SEWAGE DISPOSAL SYSTEM

HOWARD COUNTY
BUREAU OF ENVIRONMENTAL HEALTH
461-9933

SUBDIVISION Glenelg Manor II ROAD 12865 Folly Quarter Road OT 26B

RE: Building Permit
Application #72061
Lot 26B Glenelg Manor
12865 Folly Quarter Road

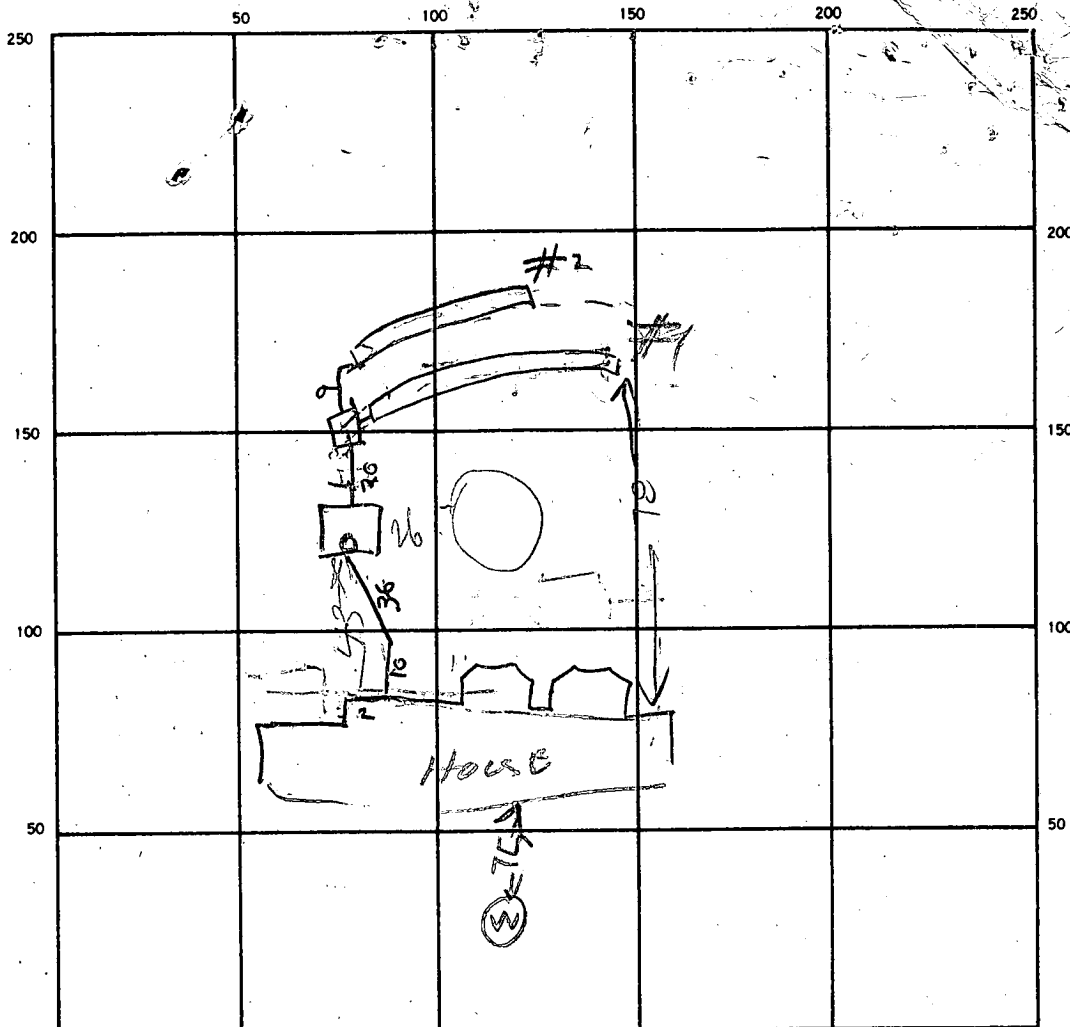
REMARKS 7/15/97 LOCATION OK OK TO COVER TANK &
 TRENCH #1 FINISH DISCHARGE TRENCH
 MARK IS 4.5 DEEP 5 FT LONG 3.5 FT STONE OR
7/15/97 TRENCH #2 OK

PARCEL 26B

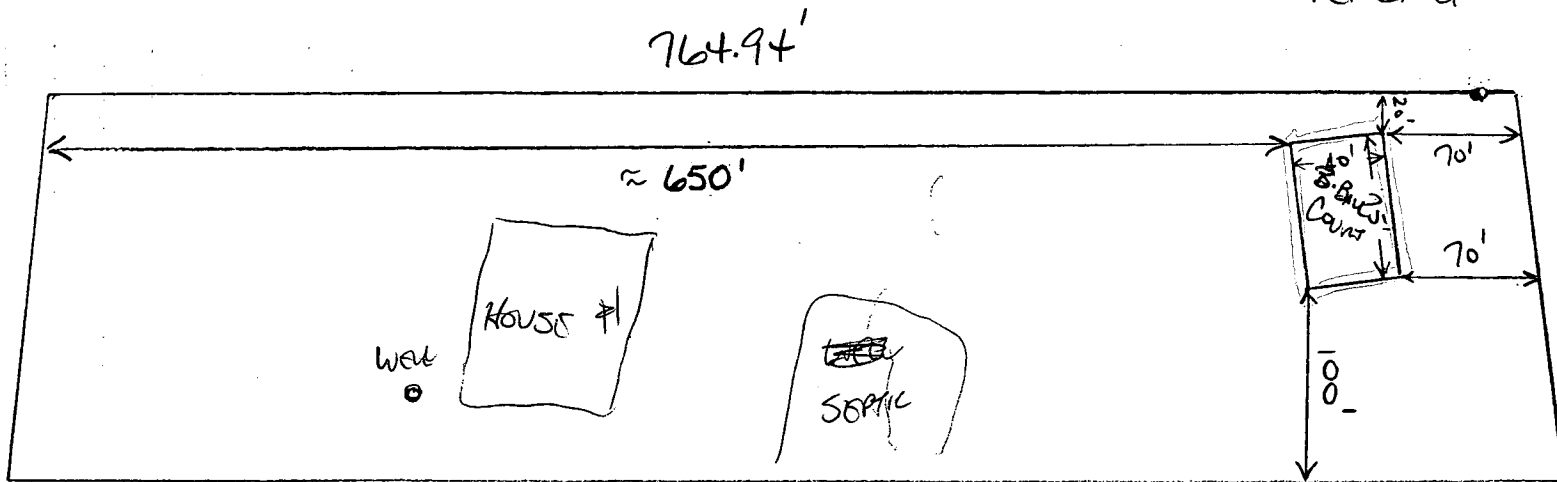
6/29/94 basket ball
proposed location had
of fence location to existing
at impact of to
NO impact of
well or septic
proceed.
An McMillan

OK
TO
Proceed
1/5/17
CW,
1/17

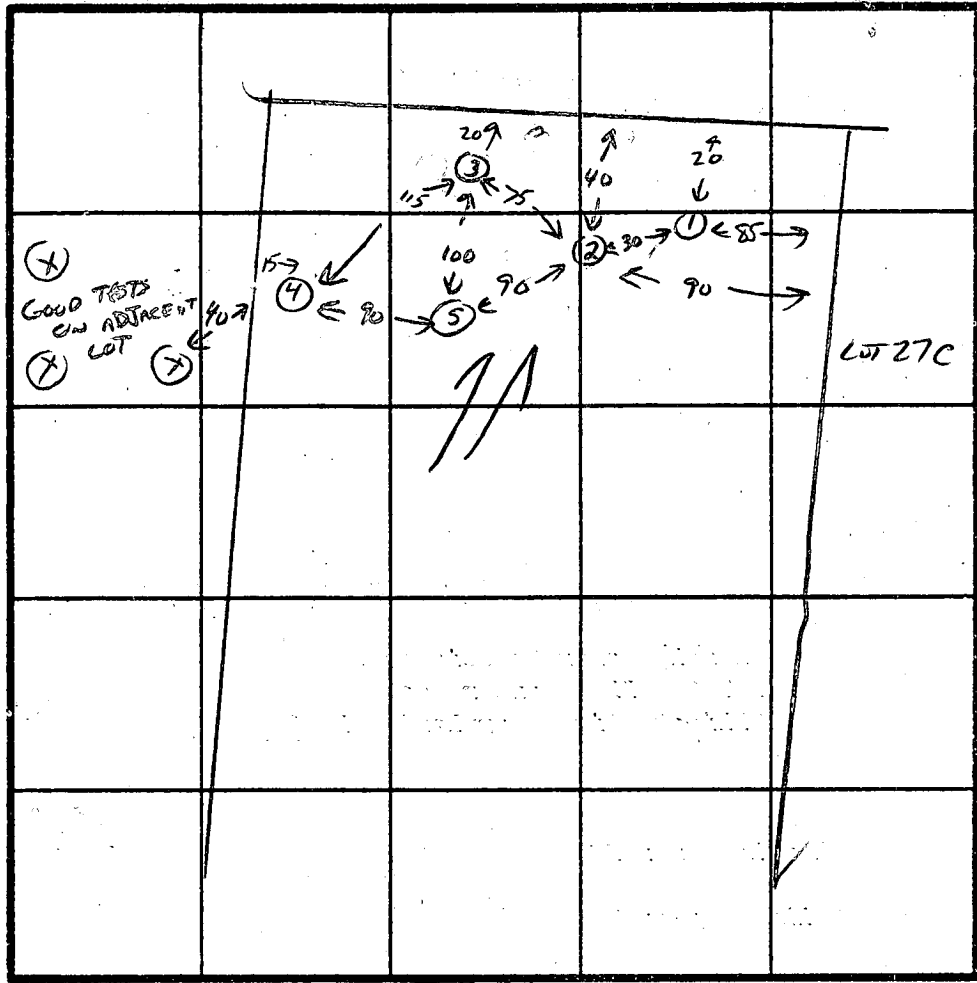
REASONS FOR REJECTION OR HOLDING HOLD FOR CERTIFIED LOCATIONS 4/22/85 CW,
OK - CW 6-10-85

LOCATIONS UNCERTAIN - LOT NOT STAKED

REMARKS RETEST NEW LOCATION - CERTIFIED PLOT REQ'D.

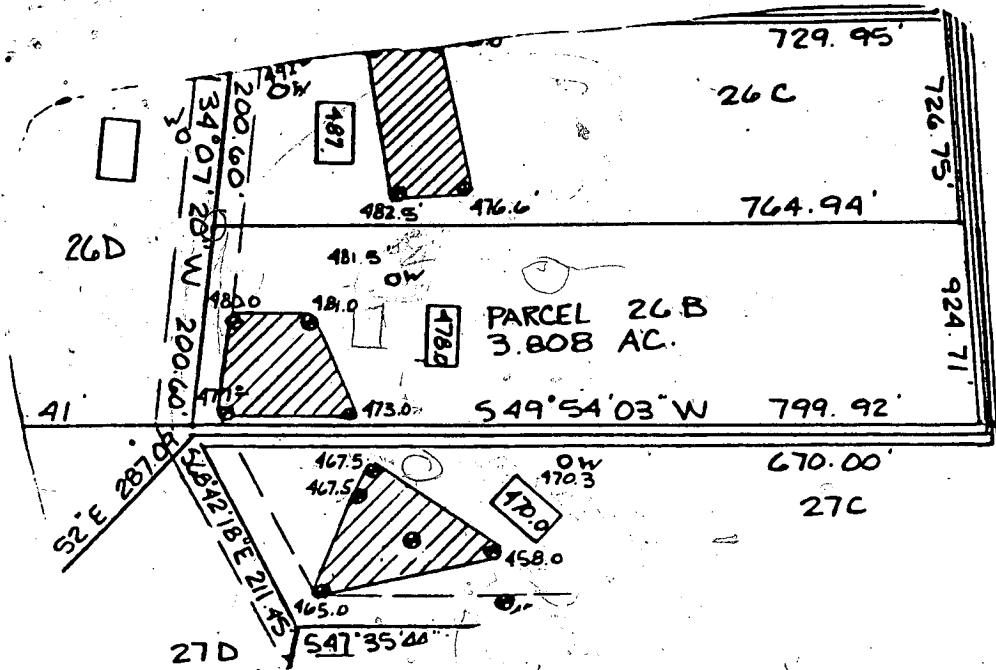
The elevation drawing submitted by you with the above referenced building permit indicates there is still a conflict with the owners plans and the limits that have been established by the health department on this property.

The house sewer line must be raised approximately 2 feet in order to reach the septic field at the specified depth. To avoid any possibility of confusion on this matter, it is now the requirement of the health department that the septic system be installed at the specified depth and location be in-stalled prior to issuance of the building permit.

LETTER FROM OWNER RECEIVED 9/28/86
INDICATING NO ATTEMPT AT BASEMENT SERVICE.
PERMIT APPROVED OK TO PROCEED 9/30/86 CWWilliams
